ADDENDUM NUMBER 3
for
ADVANCED TREATMENT PROJECT
FORT THOMAS TREATMENT PLANT
NORTHERN KENTUCKY WATER DISTRICT

FROM: CH2M HILL
TO: Plan Holders of Record

PIPING ENCASEMENT DETAIL

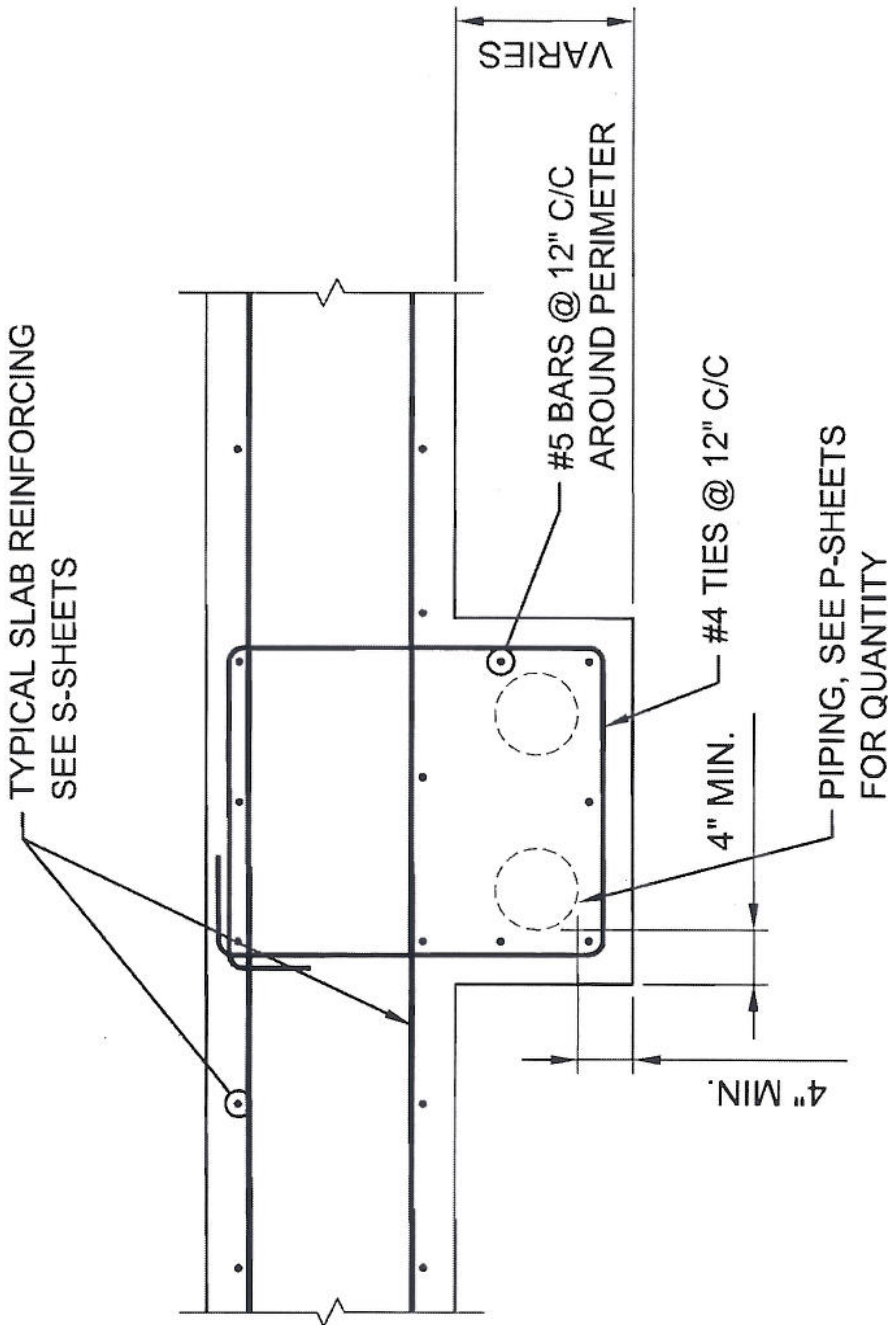
As a clarification, provide concrete encased sleeve as indicated. Any DWV piping over a water line shall be encased per code. Refer to attached detail.
